**RE: Response to Second Request for Additional Information (RAI)**  
**Facility Name: Enterprise Road Class III Recycling and Disposal**  
**Facility Site ID: 87895**  
**DEP Application No.: 177982-023-SC/T3 and 177982-024-SO/T3**

**ENTERPRISE ROAD CLASS III RECYCLING AND DISPOSAL FACILITY  
MAJOR PERMIT MODIFICATION  
ENGINEERING REPORT**

PROJECT NO.:	02000-144-14
SCALE:	AS SHOWN
DATE:	SEPTEMBER 2016
DRAWING:	<b>FIGURE 1</b>

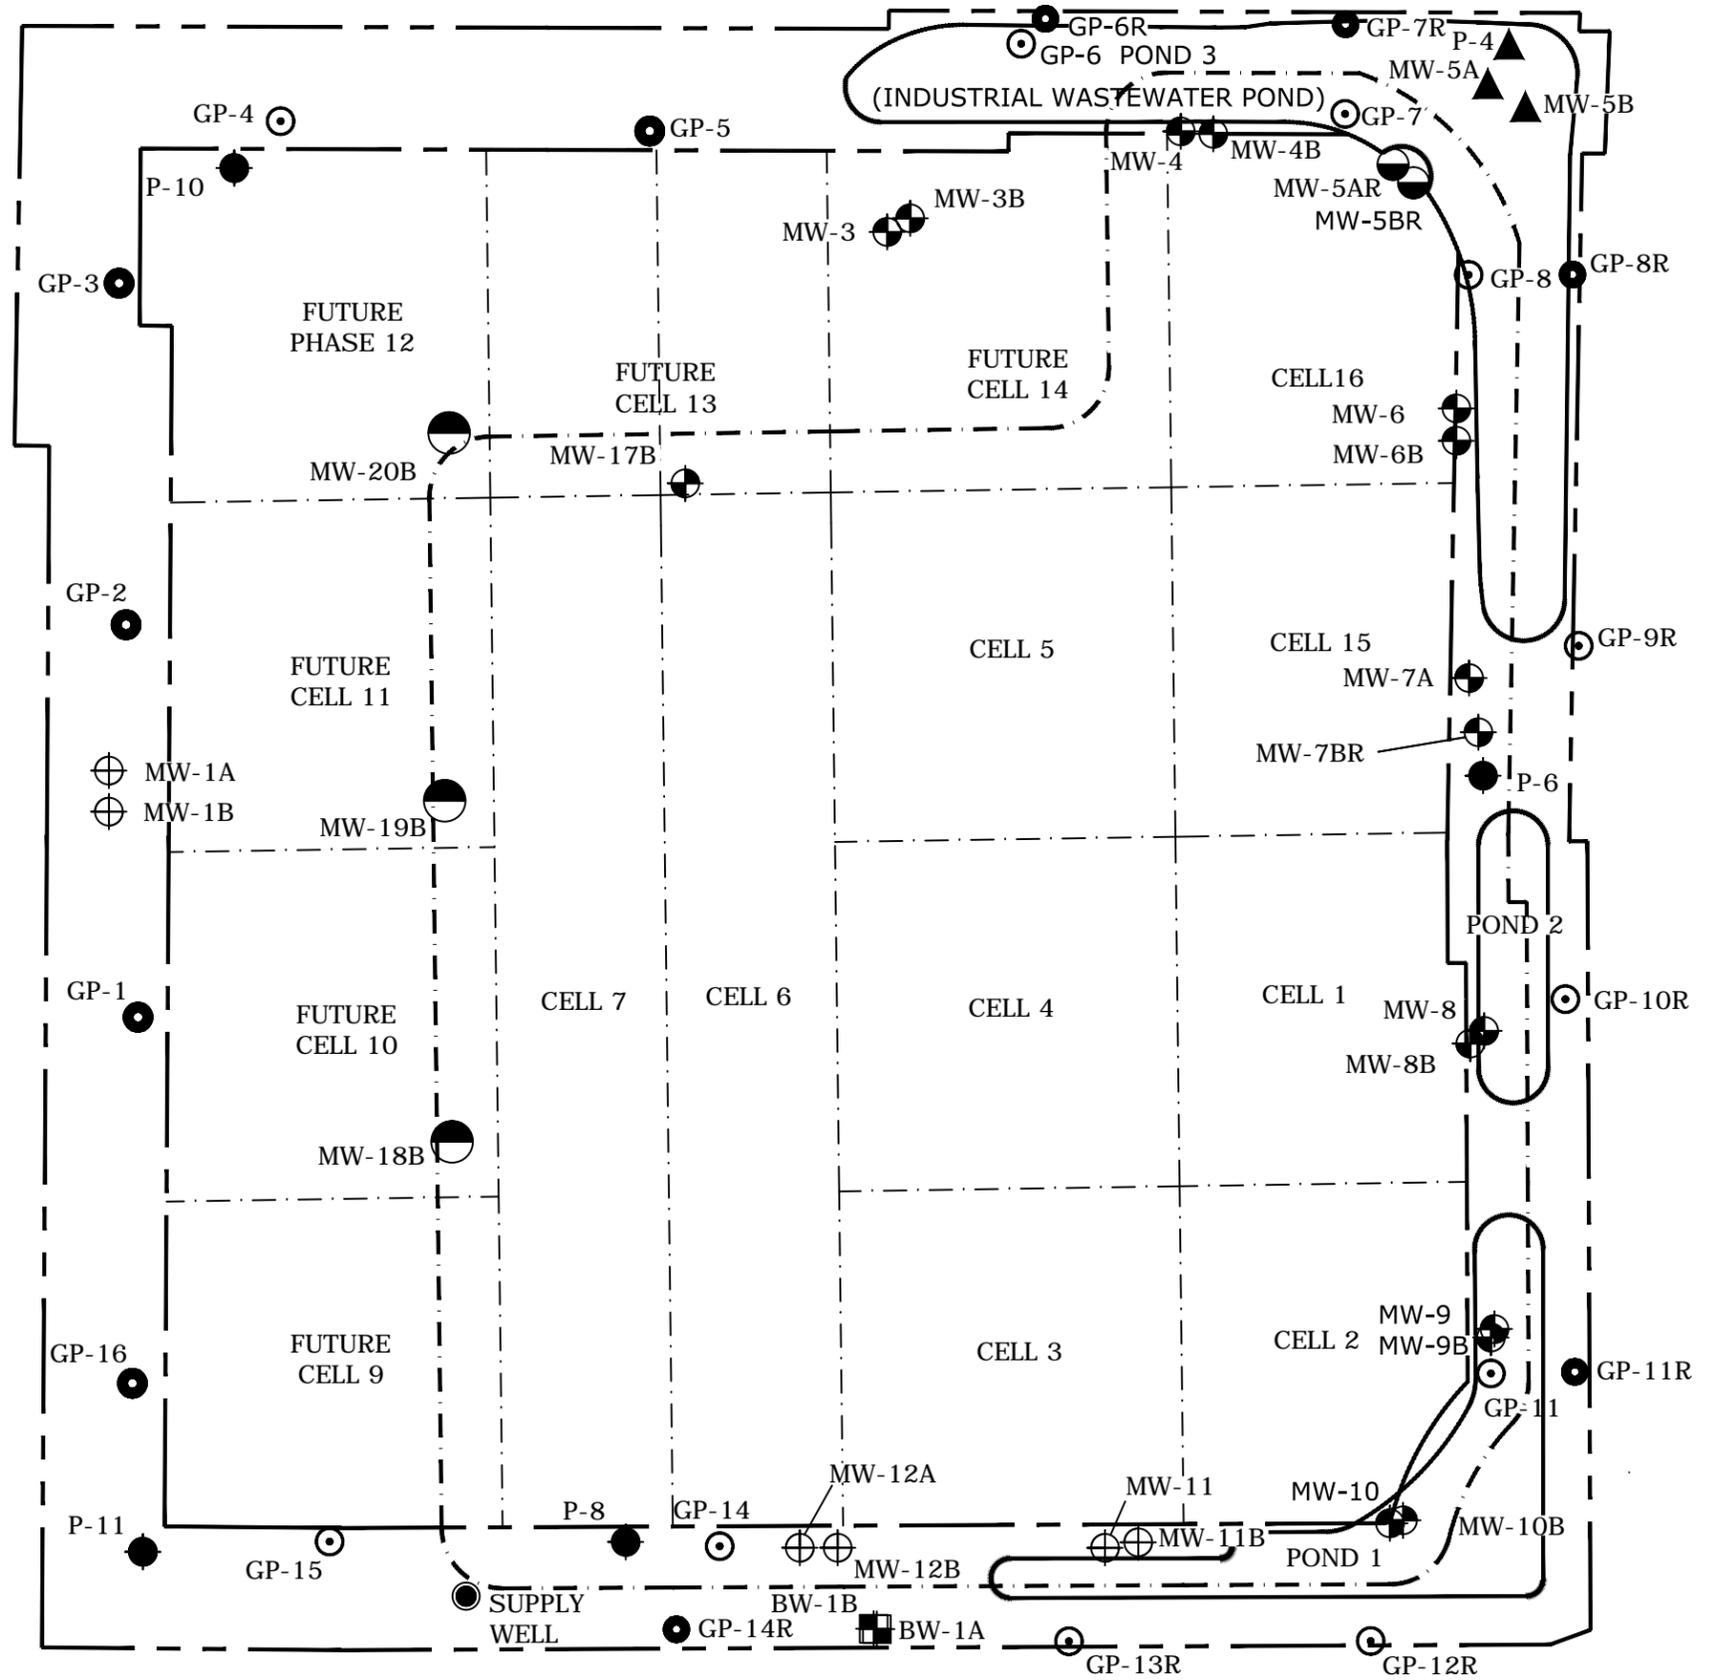
3. *§3.10.1.2: This section was revised to refer to new Table 3.10.1.2 that provided the elevations of the top and bottom of the perforated section of replacement gas probes GP-6R, GP-7R and GP-8R. Please submit revisions to Table 3.10.1.2 to also provide construction details for proposed replacement gas probes GP-11R and GP-14R. Please also provide a site map (no larger than 11 x 17 inches) that shows the existing and proposed gas probes and identification numbers for use as a permit attachment.*

**Response to Comment 3: Table 3.10.1.2 has been revised as requested. The revised Engineering Report is provided in Attachment 2. A site map showing the existing and proposed gas probes and identification numbers is provided in Attachment 4.**

REV FIGURE  
**2**

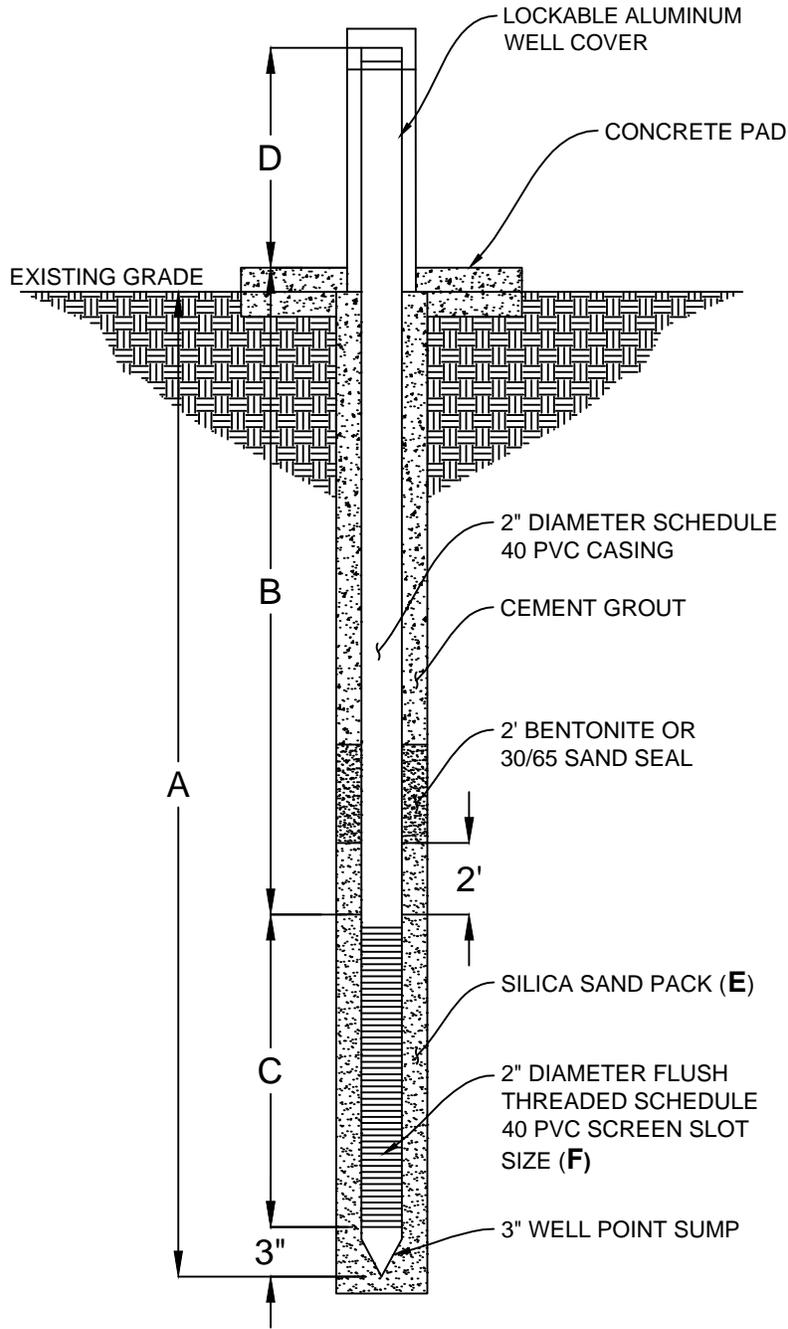
8. §1.d.: *The revisions to this section, to Figure 2 (Proposed Surficial Aquifer Monitor Well Detail), and to Figure 3 (Proposed Floridan Aquifer Monitor Well Detail) that base the construction details for future monitor wells on the lithology and water levels reported for existing adjacent wells are noted. Please also review the lithology reported for boring logs previously completed at locations in proximity to the future monitor wells as presented in the document titled “Construction and Operation Permit Application, Sid Larkin & Sons, Inc., Enterprise Class III Landfill,” prepared by Hartman and Associates, Inc. This document can be accessed in OCULUS at the following link:*

*The proposed Floridan aquifer wells should be constructed so the screened interval is set near the top of the water-bearing limestone sediments below the confining unit. For example, the construction for proposed well MW-18B places the top of the well screen (65 ft. NGVD) one foot below the low ground water elevation reported for existing well MW-15B (water elevations have ranged from 66.1 to 74.76 ft. NGVD during sampling events conducted between March 2012 and February 2016). This configuration does not appear to provide a conservative monitoring point at the top of the Floridan aquifer.*

**Response to Comment 8: Monitoring wells MW-18B, MW-19B and MW-20B have been installed as previously permitted for Cell 7. Copies of the well completion reports and initial groundwater sampling data will be provided under separate cover.**
